OEnoviaFioul Confort OSCR 45 - OSCR 60 - OSCR 90 – OSCR 120

Diagnostic aid - Evolutions

N° ITOE0232-en

31/08/2020

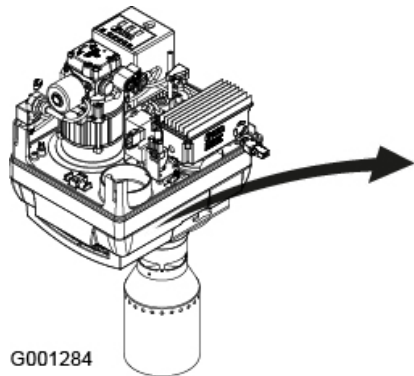
Symptoms / Error-Codes (Please also refer to the list of error codes in the manual)	Other possible causes (in addition to the causes listed in the manual)	Evolutions / Description	Appliances concerned / Application dates
<p>- Flame detection difficult</p> <p>- Ignition fault: E07.14 (Burner 1) E07.29 (Burner 2)</p> <p>- Flame loss: H01.03 E07.20 (Burner 1) E07.35 (Burner 2)</p>	<p>Under certain conditions, the KLC 2002 flame detection cell does not deliver a reliable signal (two-phase networks, floating neutral, etc.).</p>	<p>New flame detection cell IRD 1010.1.</p>  <p>Spare parts: 7611747 Flame detection cell IRD 1010.1 (red)</p>	<p>All</p> <p>17.09.2019</p> <p>from burner serial number starting with: 170919...</p>
<p>- Untimely ignition failures:</p> <p>E07.14 (Burner 1) E07.29 (Burner 2)</p>	<p>The RV safety control box with software 117 can be disturbed by the communication with the control system during the safety time, and report a "flame fault" even if the flame is detected.</p>	<p>The new software version 119 of the RV safety control box solves this problem. To check the software version, see the label:</p>  <p>Spare parts: 7661730 Safety control box BB-LMV-P</p>	<p>Mainly OSCR 60 /120 (Modification applied to the whole range).</p> <p>18.03.2020</p> <p>from burner serial number starting with: 180320...</p>

<p>- Burner motor error :</p> <p>E07.16 (Burner 1) E07.31 (Burner 2)</p>	<p>The 2 components (safety control box and motor control box) contain a motor monitoring function which can trigger a safety shutdown in case of a fluctuation of the mains voltage or micro cut-offs.</p>	<p>The RV safety control box with software 120 incorporates a new logic that increases the tolerance ranges to reduce the number of trigger occurrences. To check the software version, see the label:</p>  <p>Spare parts: 7661730 Safety control box BB-LMV-P</p>	<p>All</p> <p>Foreseen introduction date in the factory: 30.09.2020</p>
		<p>New version of the motor control box:</p> <ul style="list-style-type: none"> - Software-Version (Rev AG) : the minimum switching power of the motor control box has been lowered. - Hardware-Evolution (from serial number starting with E4...) : resistance changed to increase the high limit. <p>To check the software version, see the label:</p>  <p>Spare parts: 7661523 Motor control box for modulating burner.</p>	<p>All</p> <p>18.03.2020</p> <p>from burner serial number starting with : 180320...</p>
